From: Kevin Kujawa <kevinkujawa1@gmail.com>
Sent: Friday, September 2, 2016 12:41 PM
To: APC
Subject: docket number 1609-PUD-17

From: Heather Raymond - Personal <hnraymond@gmail.com>
Sent: Wednesday, September 7, 2016 4:06 PM
To: Daine Crabtree
Cc: 'Bill Lambert'
Subject: FW: 15807 Longship Court (Docket No. 1609-PUD-18)
Attachments: image002.emz; Raymond view of pool 2.JPG; Raymond back patio - view of pool.jpg

From: Jesse Pohlman [<mailto:jpohlman@westfield.in.gov>]
Sent: Thursday, August 18, 2016 8:39 AM
To: Bill Lambert <BLambert@permapools.com>
Cc: Daine Crabtree <dcrabtree@westfield.in.gov>
Subject: 15807 Longship Court (Docket No. 1609-PUD-18)

Thanks for giving me the opportunity to speak at the public hearing for 1609-PUD-18 this past Tuesday evening. This is the first time that I have been involved in a matter of this type so I may have missed a couple points of interest that I'd like to clarify and add some further comments to. This is a request for a reduction in the rear yard setback from 25' to 15' to allow the homeowner to construct a swimming pool.

LOT # 29
 ±12,838 SF
 PAD 894.1 PER PLAN

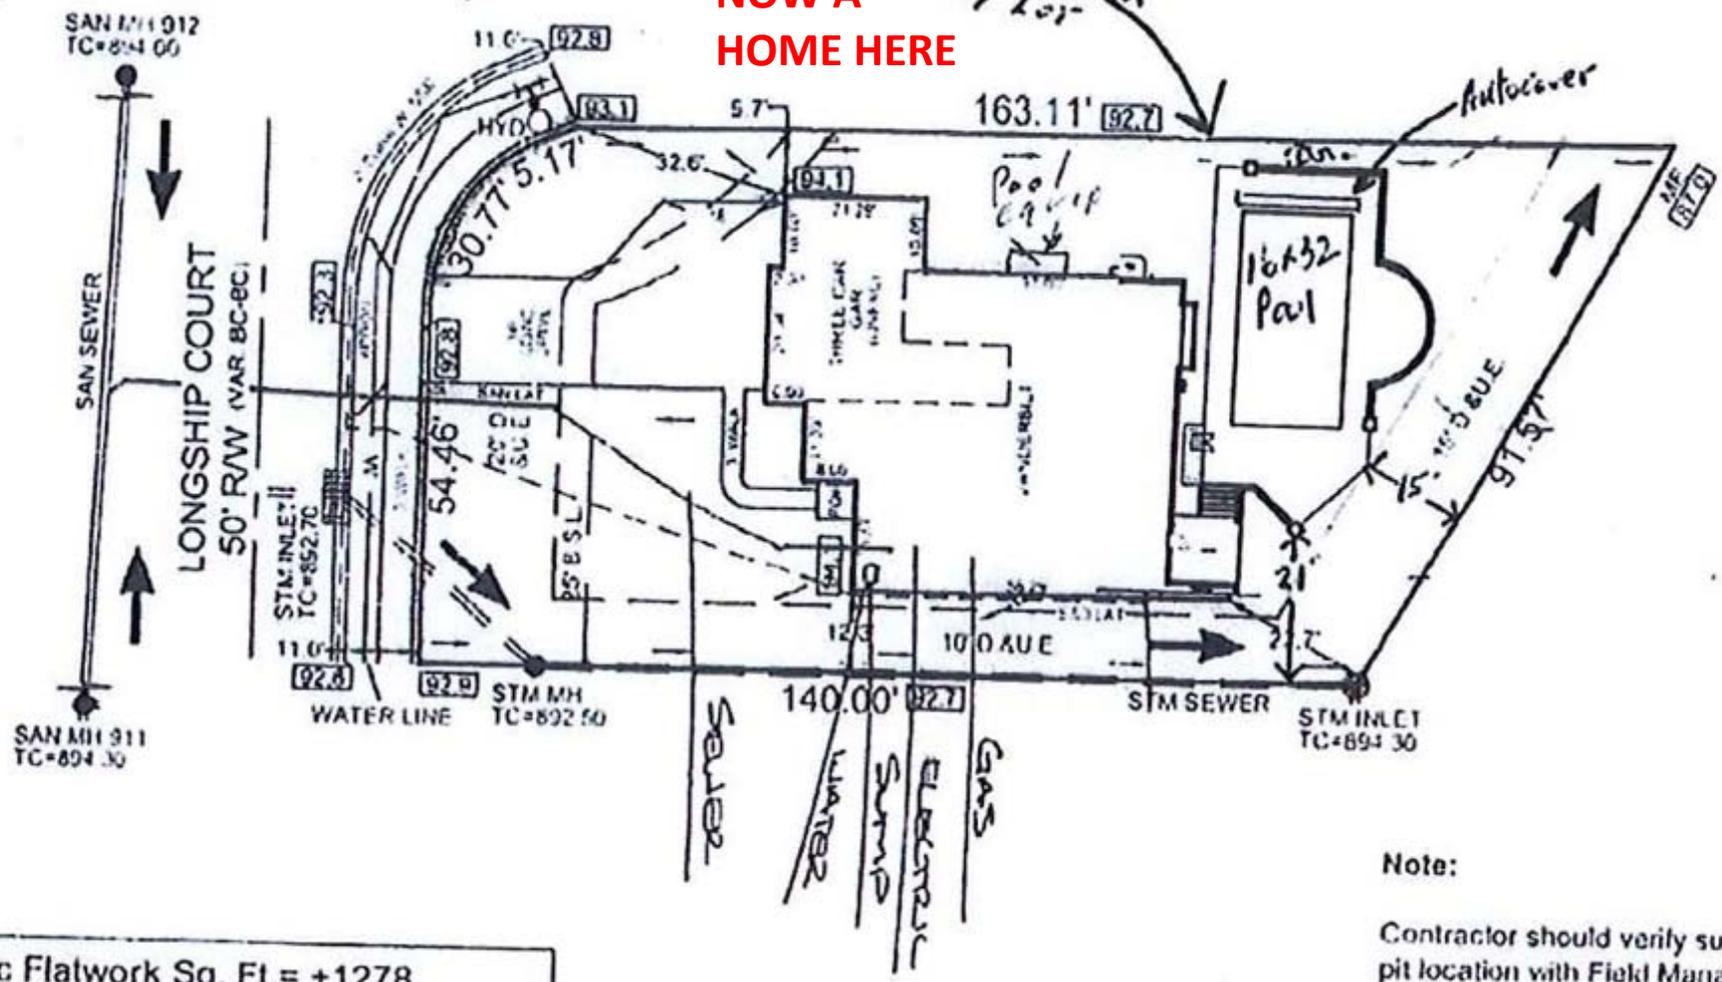
In this specific case my lot backs up to a small field, but also to another home site where the division (yard line) is at an angle. My lot is about average size for the area, but the lot in question is unique in shape (and size) and as a result, came with some limitations. Due to the overall plat the rears of our homes are already the closest of any. In addition to close proximity, the elevation is a major factor in this matter. There is a drop of about 5'-6' from the rear of the house to the back of the lot. Therefore, any additional improvements (like a pool) would require either a significant amount of fill, a drop-down right at the house, a retaining wall behind the pool, or a combination of both. In addition to reducing the setback to only 15', the drop-off creates another obstacle that makes this change even more unacceptable. The need for a fence adds another layer of complexity. Depending on where/how a fence is constructed it may be useless, or further violate the setback.

The city (and developer) created the standards for a reason. The setback (buildable area) of any lot is critical and is always a major factor, especially with smaller lots. To now allow for a reduction in the setback is totally against the intent to create the necessary buffers. Also, the application included a drawing showing the details of the site. It states there is "access thru empty lot" to the north. Please be aware there is now a totally finished and landscaped home on the adjacent lot. It is NOT empty.

The facts of this matter are very clear and the existing minimum standards should not be further reduced. I encourage you to personally look at the site to see the situation. What is being asked for and shown on the proposal does not tell the entire story of the actual building site.

NOW A
 HOME HERE

ACCESS THRU
 EMPTY LOT
